**Pacific Gas and
Electric Company®**

PG&E Letter DCL-13-043

Diablo Canyon Units 1 and 2
Docket No. 50-275, OL-DPR-80
Docket No. 50-323, OL-DPR-82
Supplement to License Amendment Request 11-07, "Process Protection System Replacement"

Figure 4-3 Simplified Diablo Canyon Process Protection System (After Replacement)

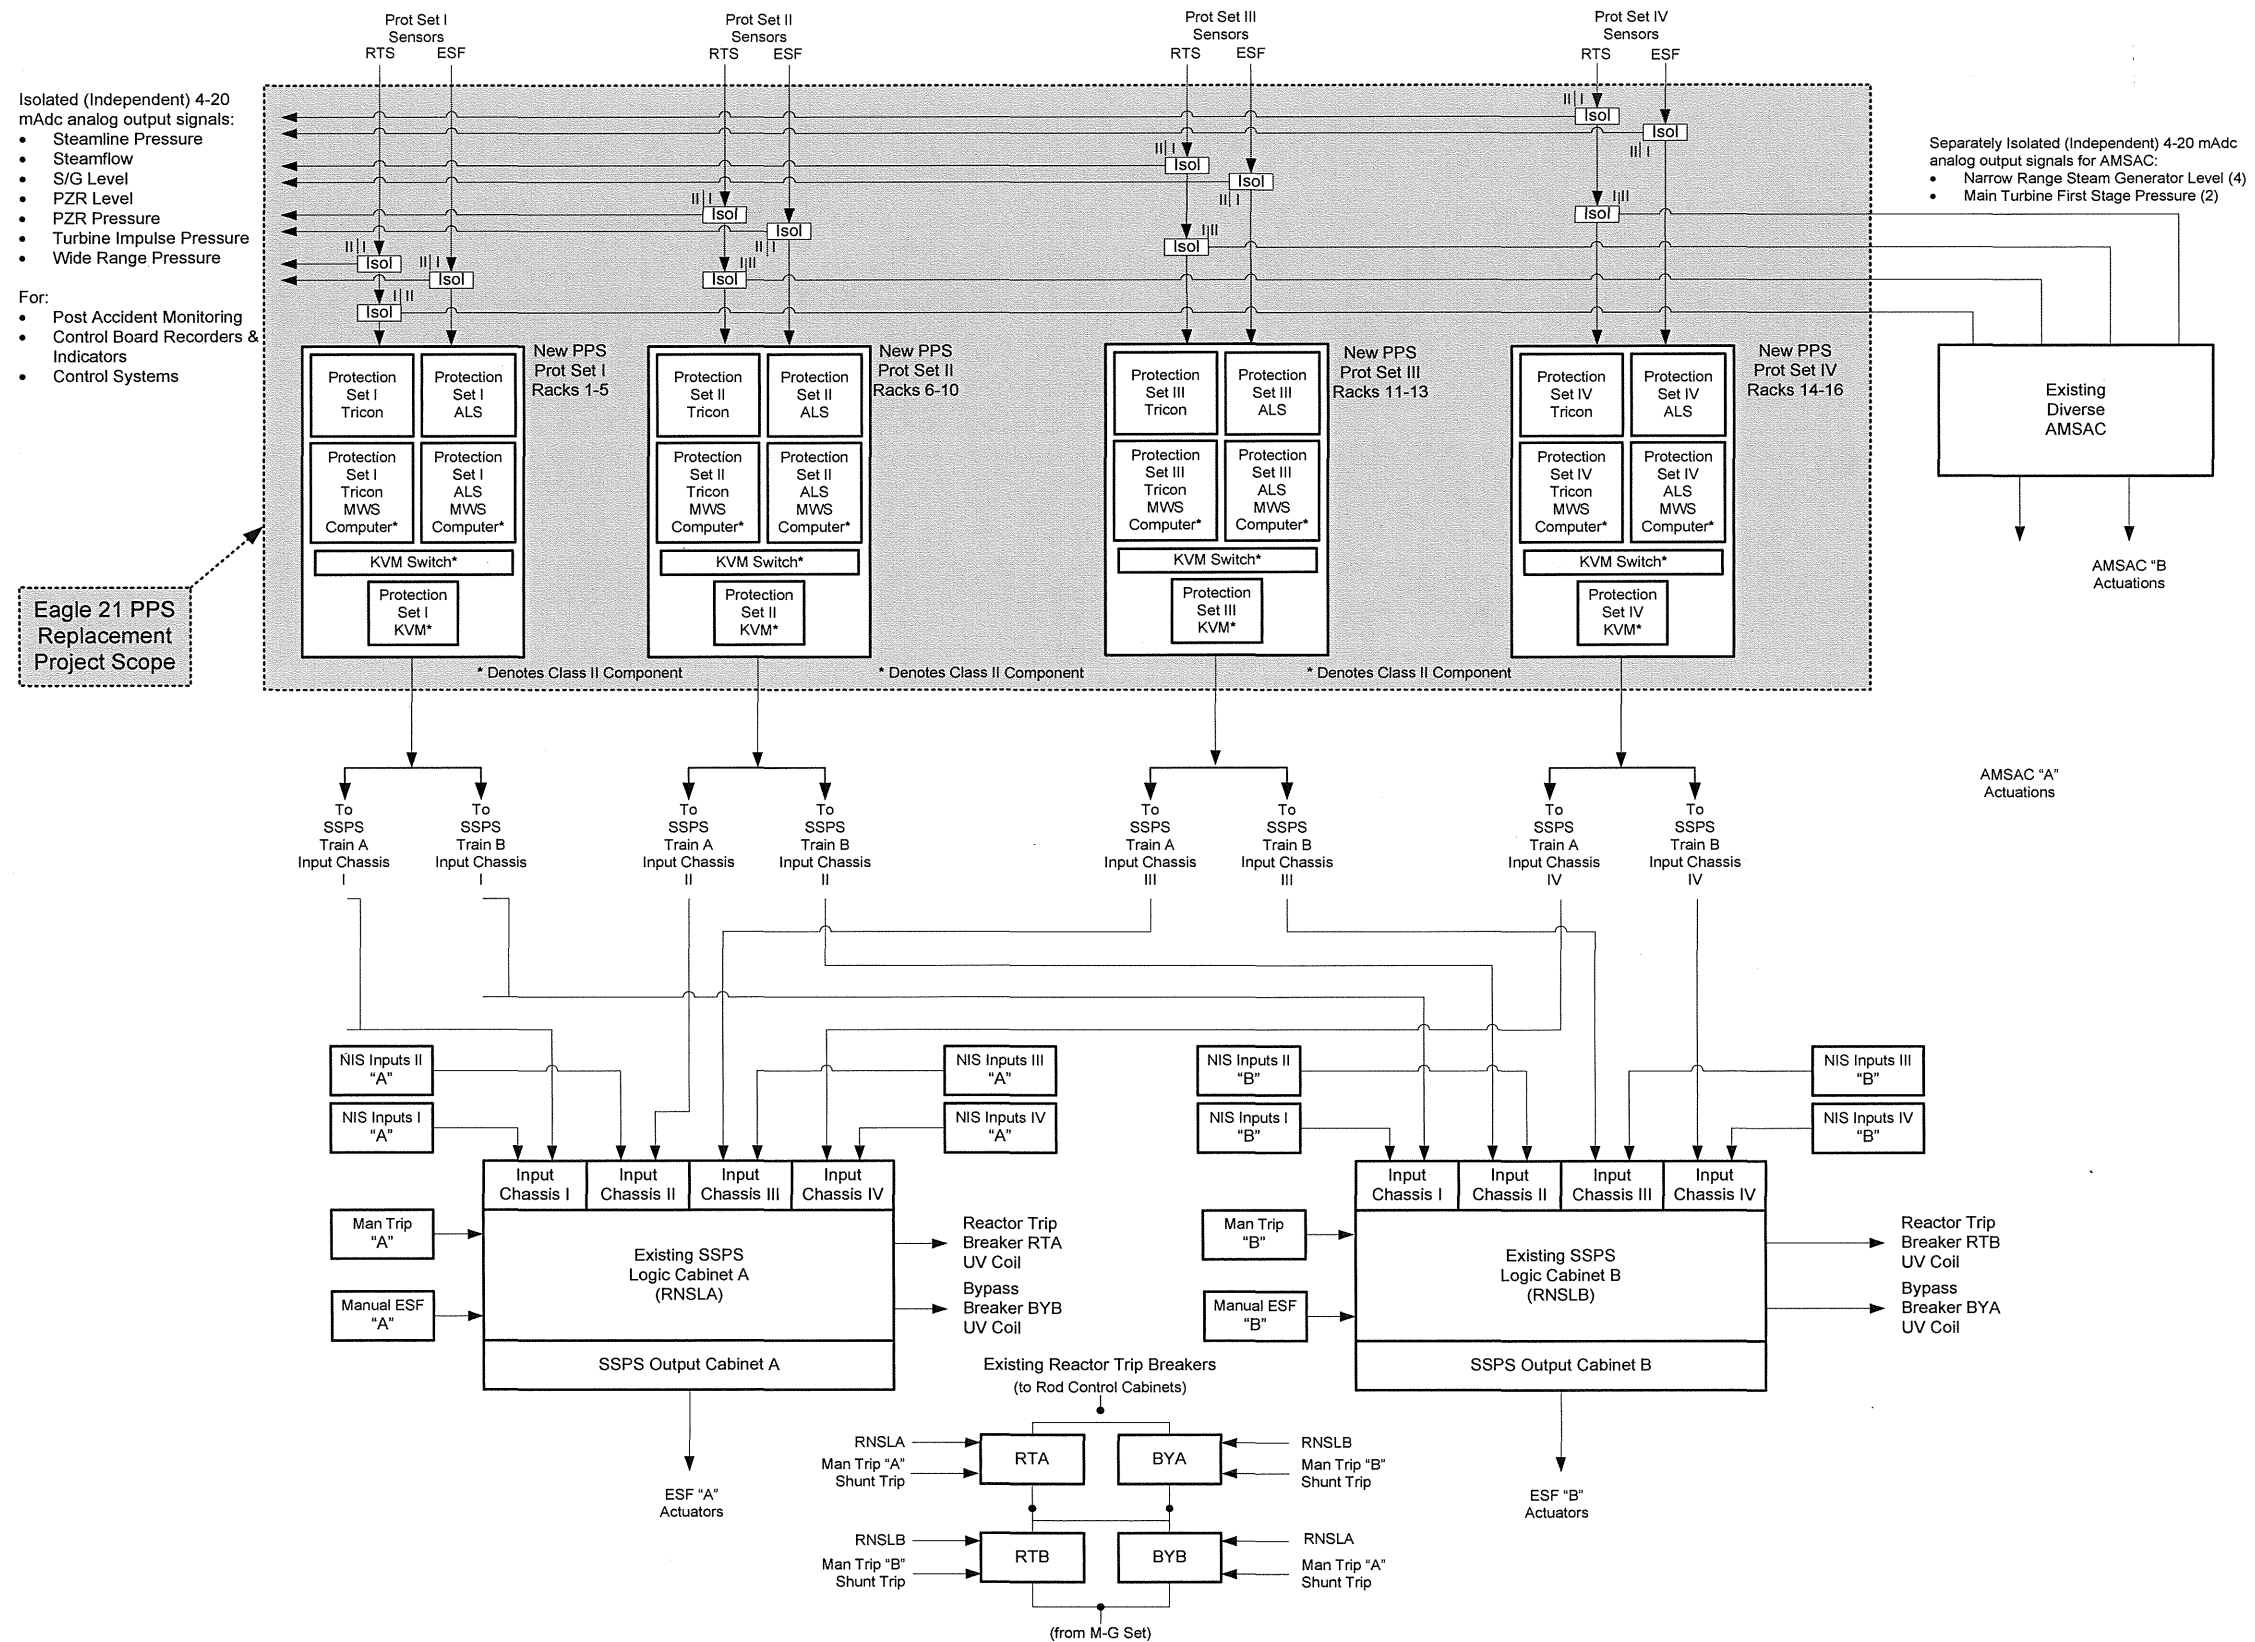
The PPS Replacement Project replaces in its entirety the Westinghouse Eagle 21 PPS hardware currently housed in PPS Racks 1 – 16 as illustrated in the shaded portion of Figure 4-3 (corresponding to the shaded portion of Figure 4-1). Equipment in the unshaded portion of Figure 4-3 is not being replaced or modified by this project.

PPS replacement functions are implemented in the same four (4) redundant Protection Sets shown in the shaded portion of Figure 4-3 as the existing Eagle 21 PPS. Each Protection Set uses a software-based Triconex Tricon processor described in Tricon V10 Topical Report Submittal [13] to mitigate events where the previously approved DCCP Eagle 21 PPS Replacement D3 Analysis [6] determined that existing diverse and independent automatic mitigating functions are available to mitigate the effects of postulated CCF concurrent with FSAR [26] Chapter 15 events. For the events where the DCCP PPS Replacement Diversity and Defense in Depth Analysis [6] determined that additional diversity measures were necessary to preclude manual mitigative action, automatic protective functions are performed in the diverse safety-related CSI ALS described in the ALS Topical Report Submittal [15] shown in the shaded portion of Figure 4-3. The PPS Replacement D3 strategy is described in Section 4.7 of this LAR.

Figure 4-12 PPS Replacement Communications – All Protection Sets

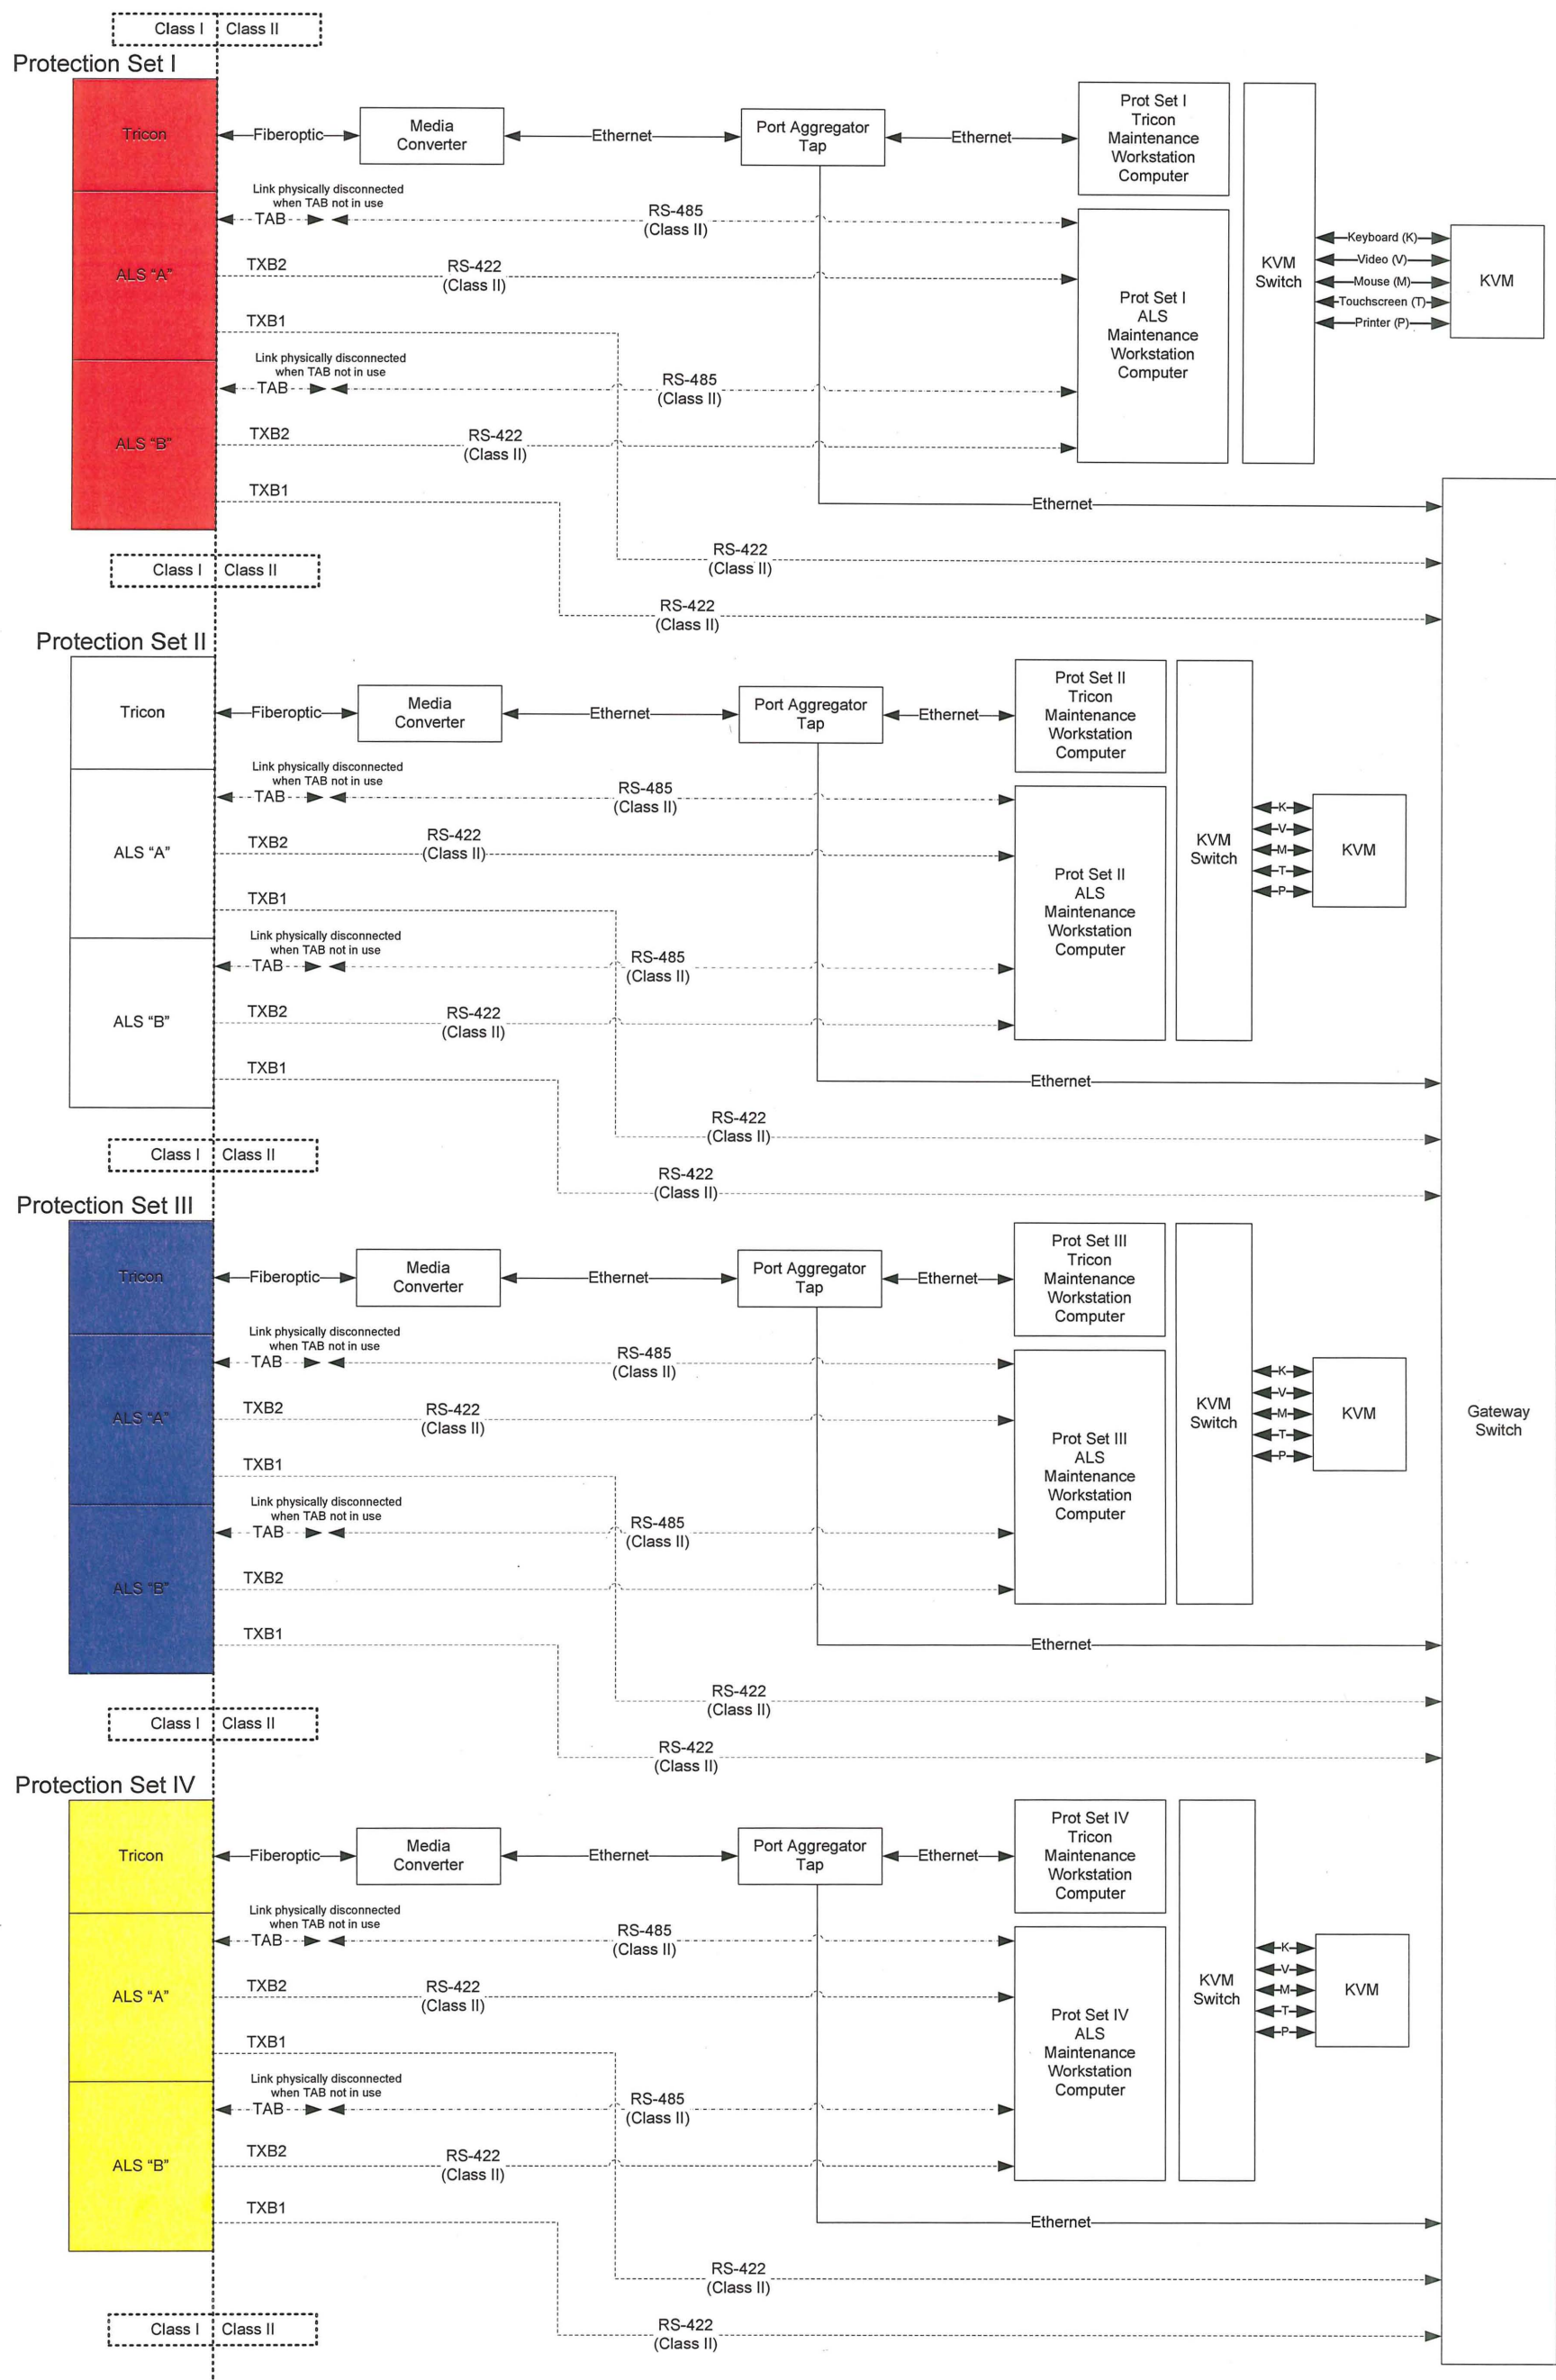
Each Protection Set in the PPS replacement is provided with a separate dedicated non-safety-related MWS for the Tricon subsystem and the ALS subsystem for the purpose of maintenance and calibration. The Tricon MWS and ALS MWS within a redundant Protection Set are connected to and communicate with the safety-related equipment in the associated Protection Set. The Tricon and ALS MWSs are not connected to and cannot communicate with safety-related equipment outside its associated Protection Set. Refer to Figure 4-12.

The non-safety-related Tricon MWS shown in Figure 4-3, Figure 4-12, and Figure 4-13 is used to maintain and configure the Tricon and also to view the data from the Tricon. The non-safety-related ALS MWS shown in Figure 4-12 is used to view data from the ALS subsystem. Also, the ALS MWS, when physically connected to the TAB and when the TAB has been placed in service, is used to perform the maintenance functions associated with the ASU described in Section 2.6.3 of the ALS Topical Report Submittal [15].
